TROY ARCHITECTURE PRACTICE, PLLC.

Re: PLPC 2024 0024

Attached please find TAP's amended materials related to site plan review for Adler Place. We are hopeful to be included on the January 21 Planning Board agenda for Final Review.

Regarding **PLPC 2024 0024** please see the following responses in blue italics to the staff report received 12/12/2024.

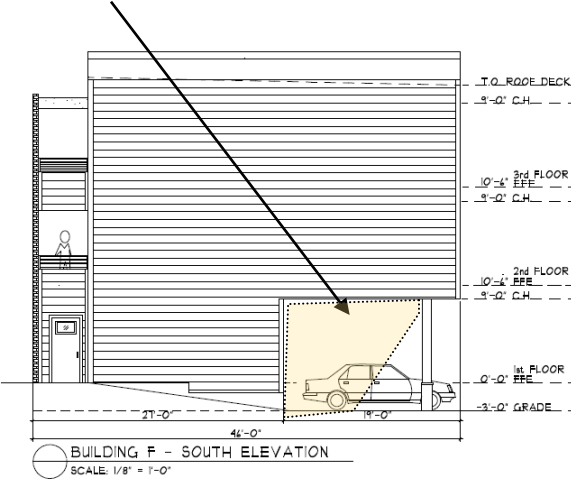
- **Provide snow storage locations** *Please see diagram above and elevation below. There is no snow storage needed. The parking spaces are covered by the second floor of Building F. A*

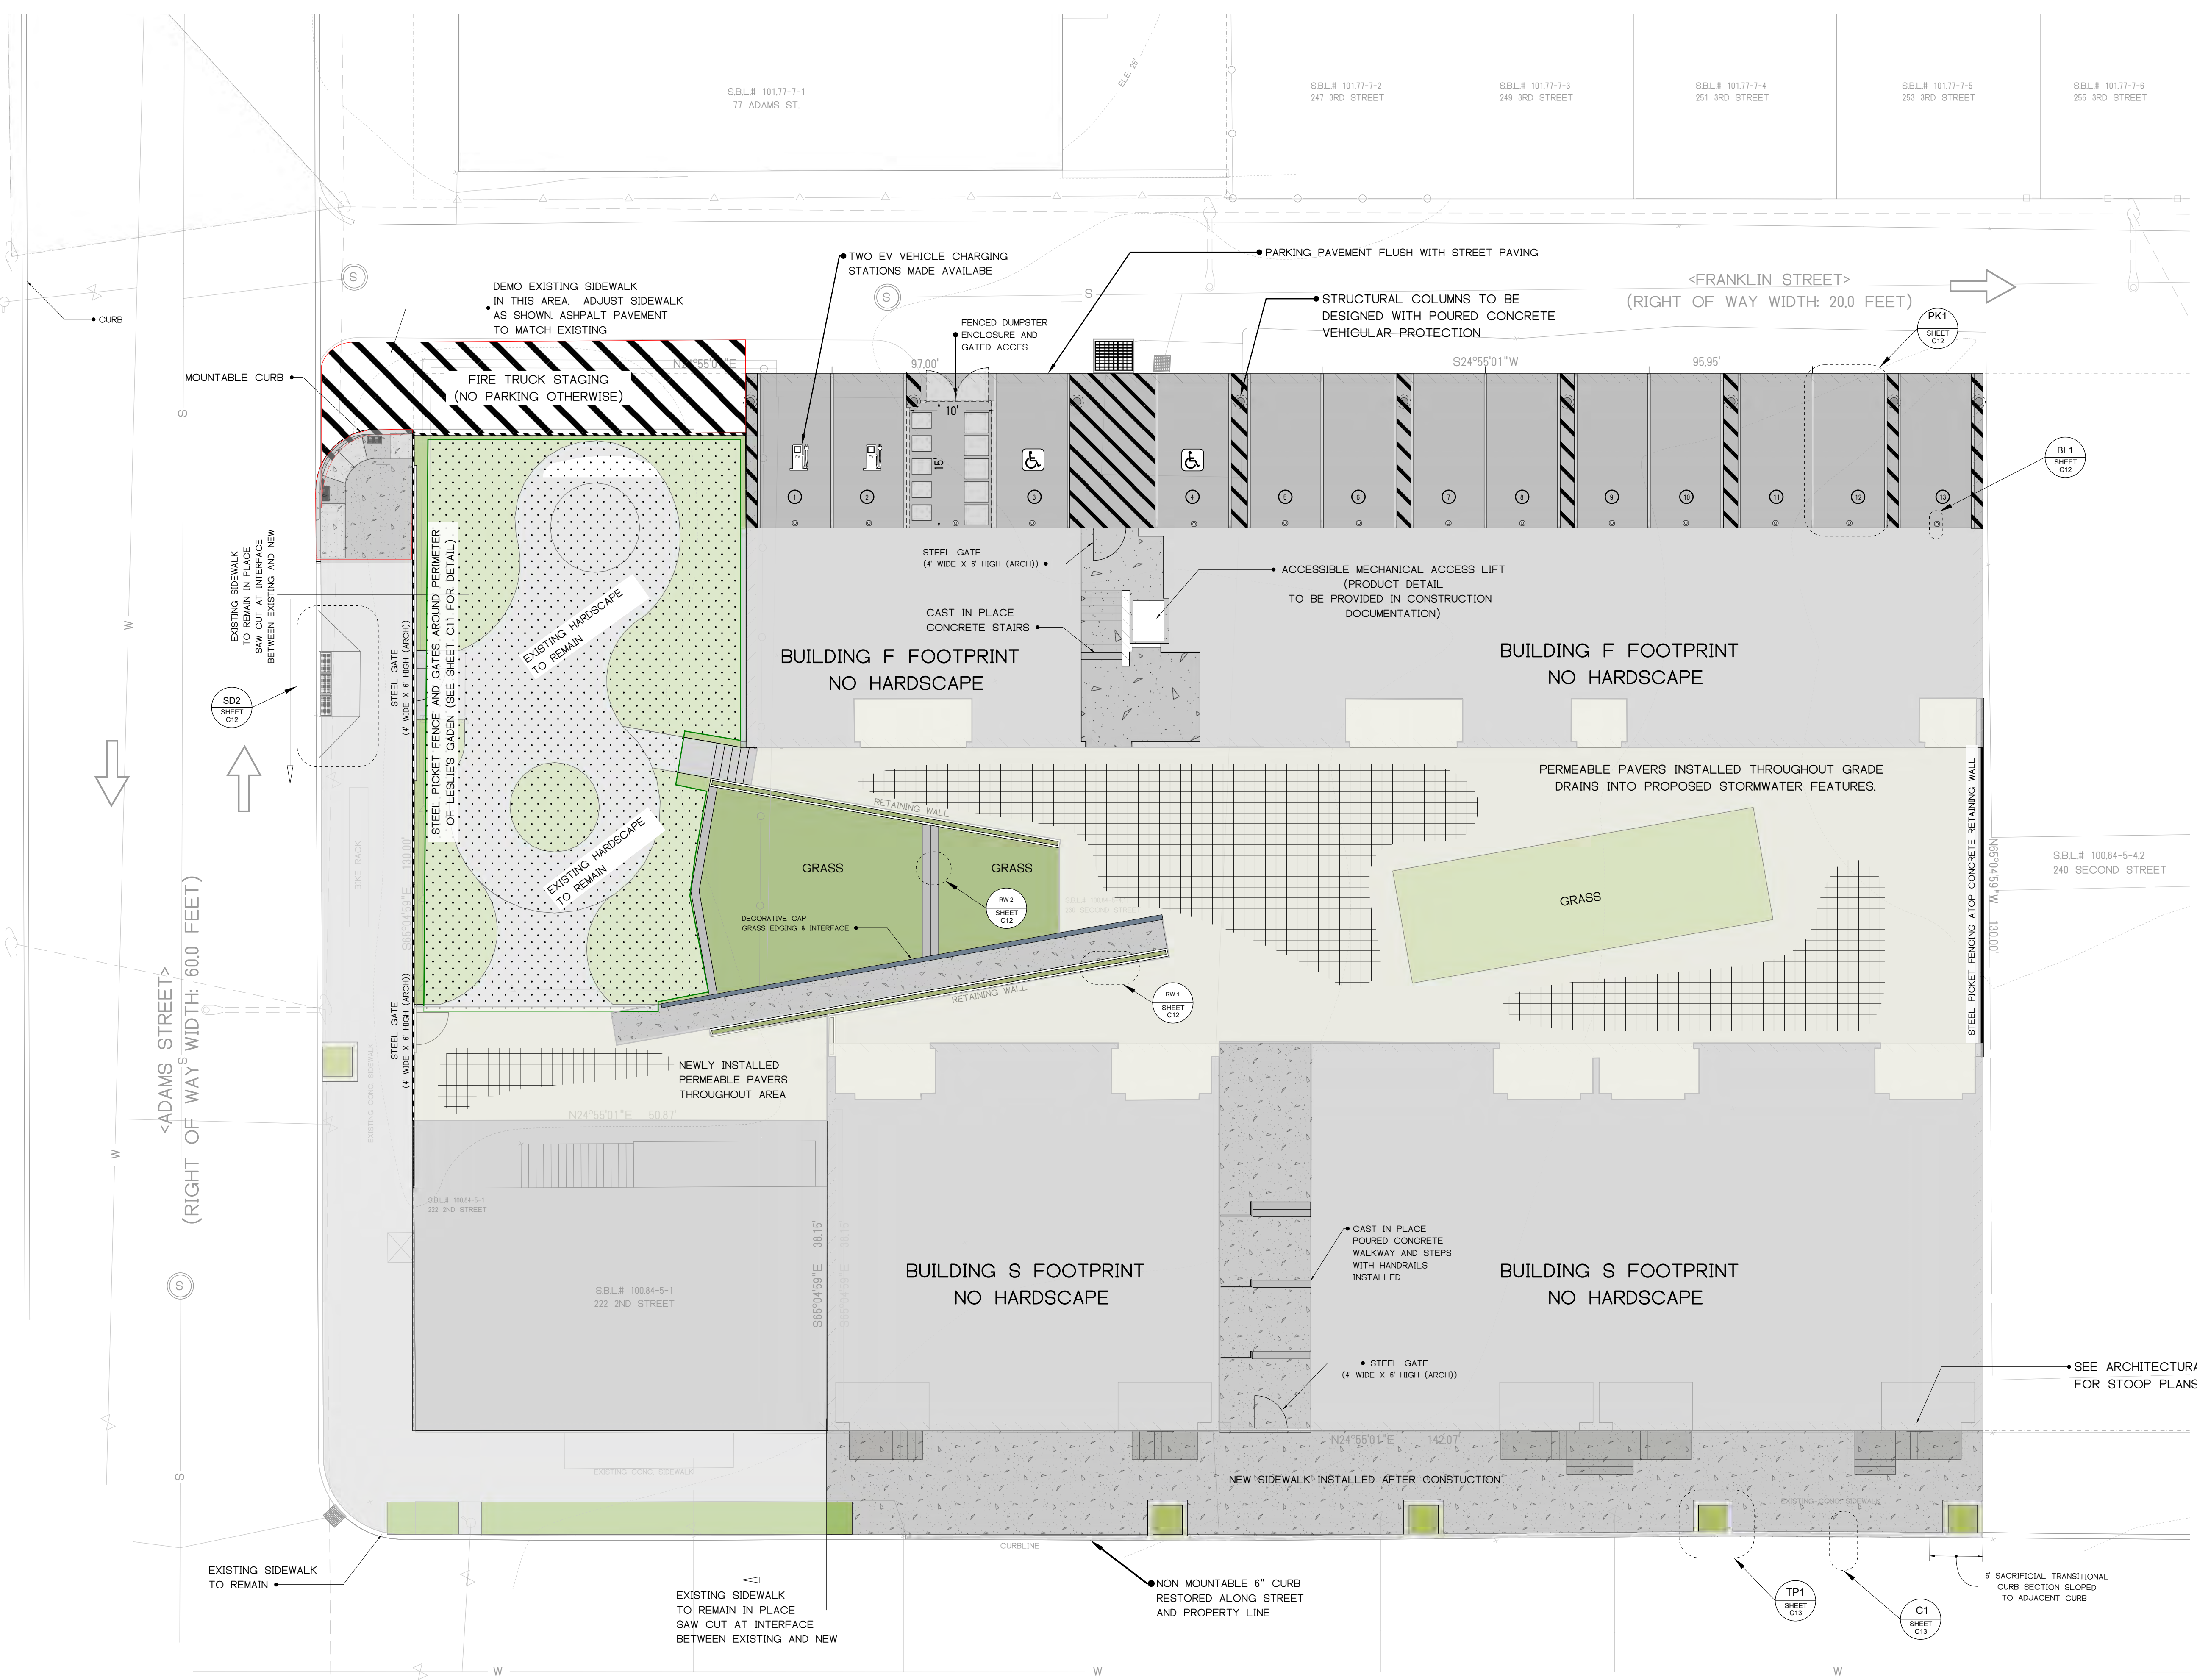
- Provide additional details on lighting. Fixtures, posts, lumens, footcandles, etc. *Details will be provided*
 - Applicant to provide garbage location/plan. *Fenced enclosure for 95 gallon rolling trash bins is shown on Sheet C7.*
